STAFF REPORT	
COMMUNITY DEVELOPMENT DEPARTMENT

HEARING DATE: March 28, 2023

SUBJECT: Newkirk Neighborhood AZ, PP
H-2022-0088

B. Preliminary Plat (dated: 10/21/22 03/29/23) **NOT APPROVED**

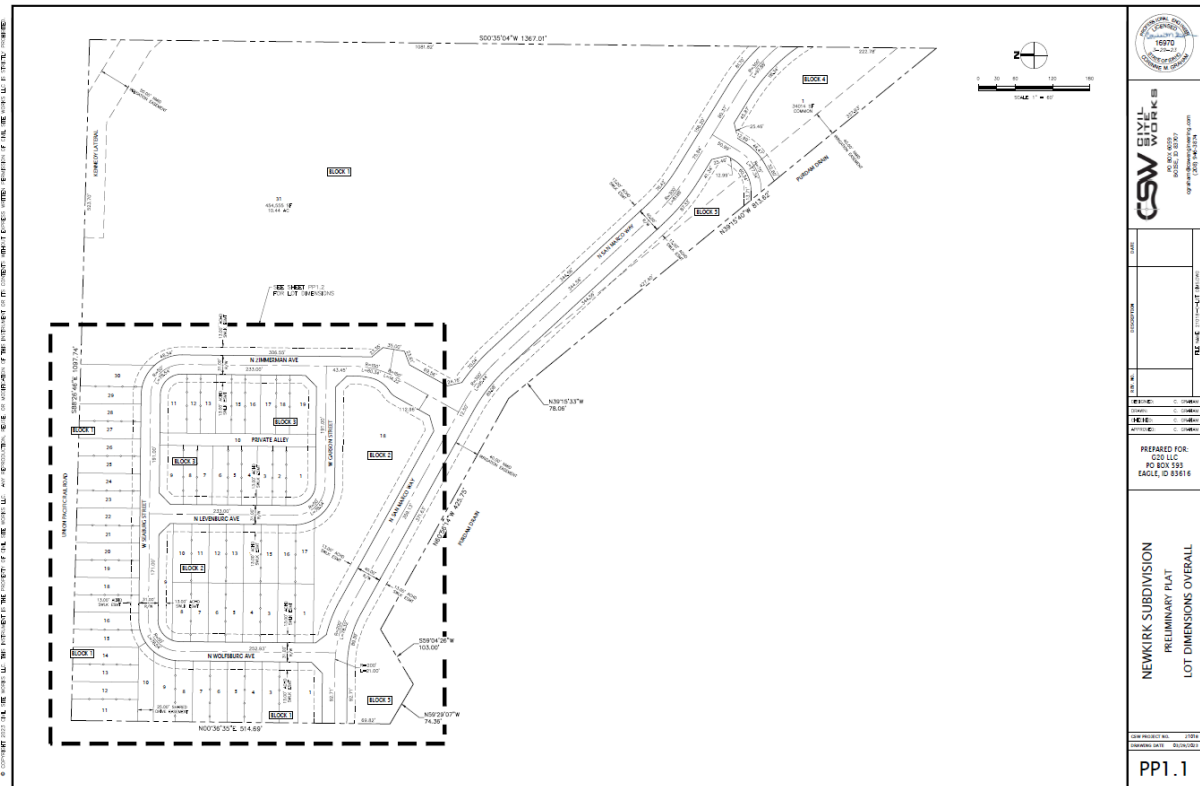
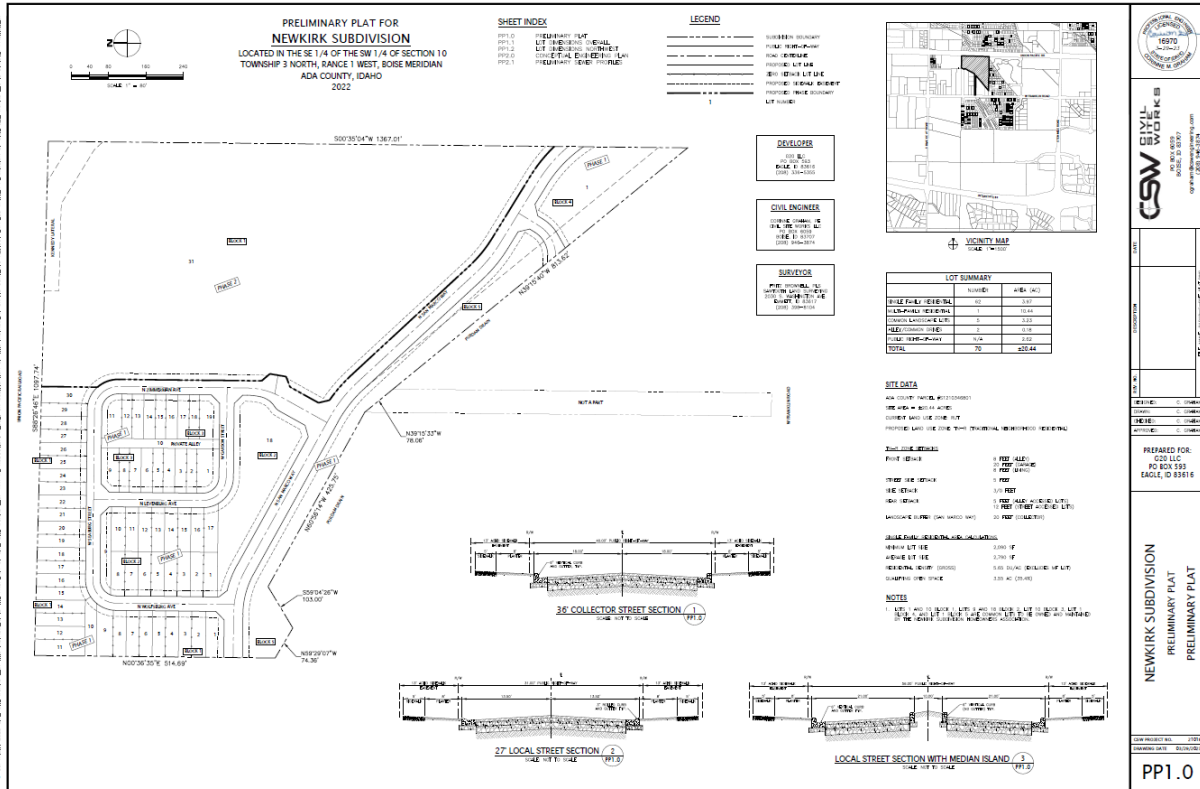
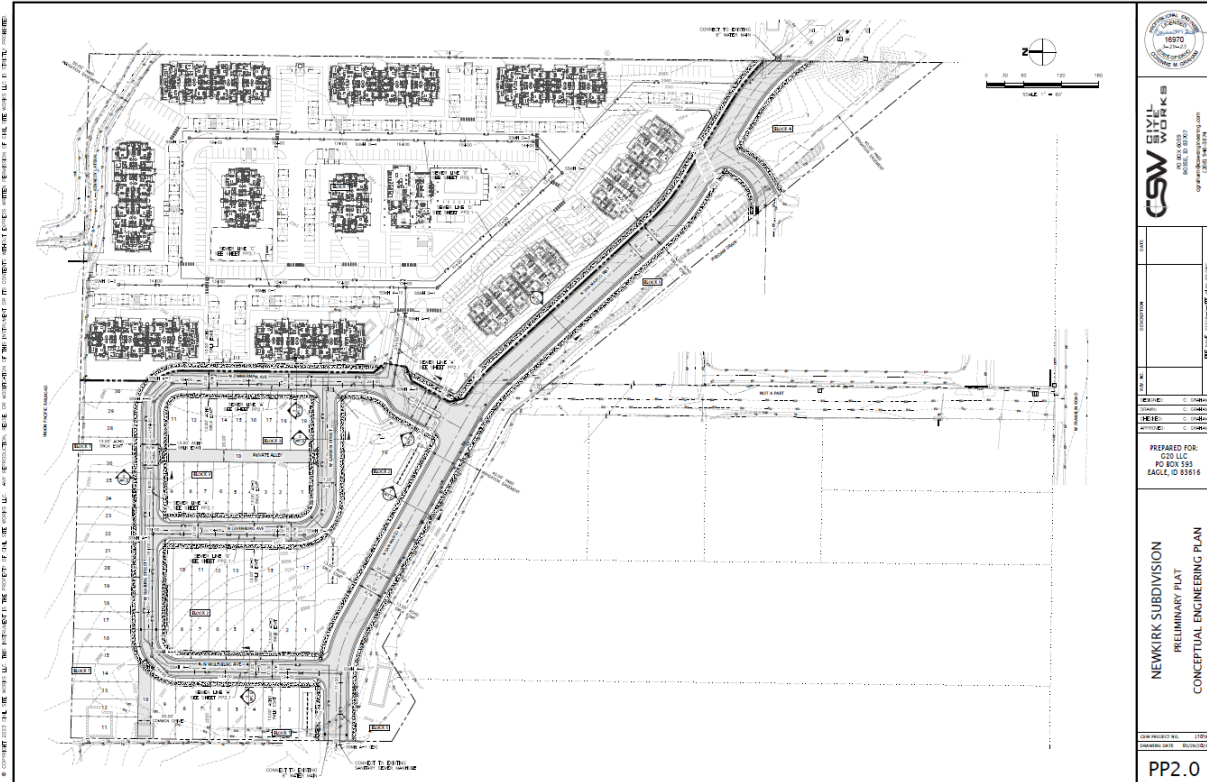
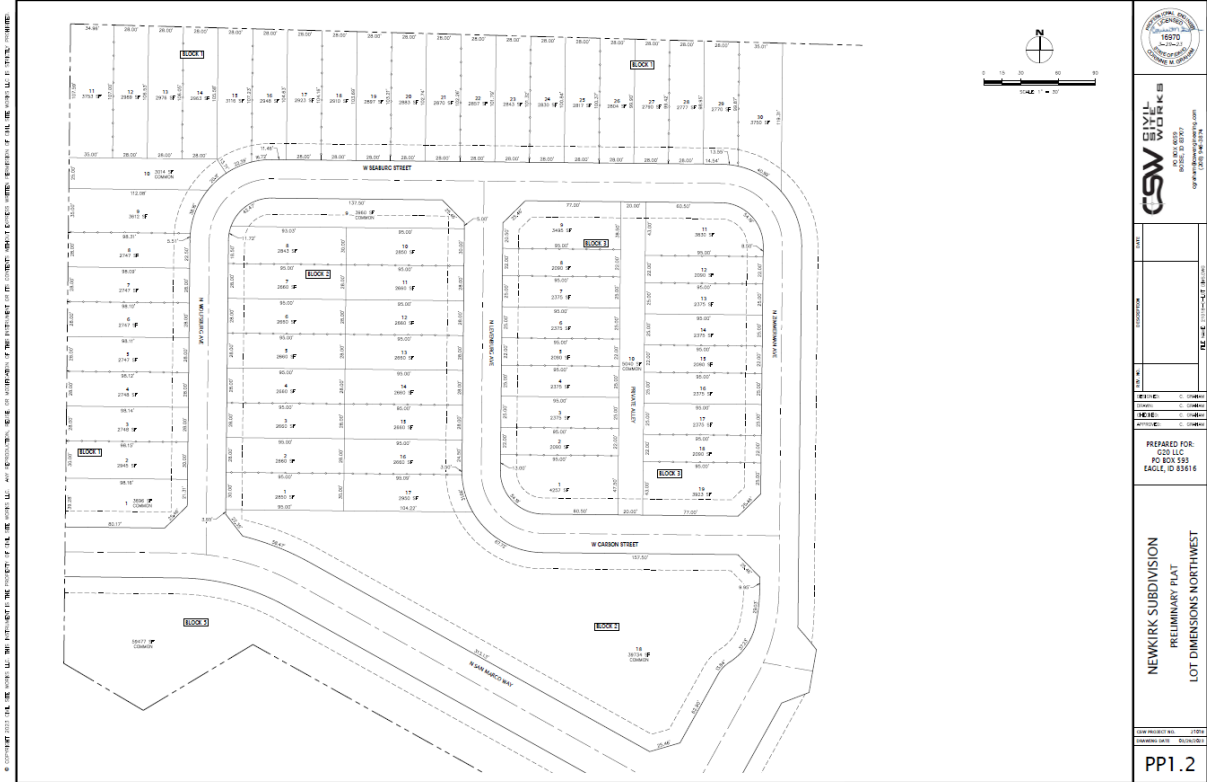
This property and three (3) properties to the south take access from Zimmerman Ln., a private street; two (2) of these properties don't have public street frontage. **ACHD is requiring Zimmerman Ln. to be dedicated and improved as a local public street in order to provide a north/south street connection between Franklin Rd. and the collector street, public street frontage for the two parcels to the south, and access to Ascent Subdivision from a local street, which will enable their temporary vehicle access to be converted to emergency and pedestrian access only. The plat should be revised accordingly.**

Three (3) stub streets (i.e. E. Chair Lift St., W. Atomic St. and W. Ski Hill St.) exist in Ascent Subdivision that are required to be extended with development as required by ACHD.

Common Driveway (UDC [11-6C-3D](#)): One (1) common driveway is proposed at the northwest corner of the site on Lot 10, Block 1 for access to Lots 11-14, Block 1. Common driveways are allowed to serve a maximum of four (4) dwelling units; in no case shall more than three (3) dwelling units be located on one (1) side of the driveway. **A total of four (4) dwelling units are proposed on the north side of the driveway; the final plat and common driveway exhibit shall be revised to depict a maximum of three (3) units on one (1) side of the driveway as required; or, alternative compliance may be requested as set forth in UDC [11-5B-5](#).**
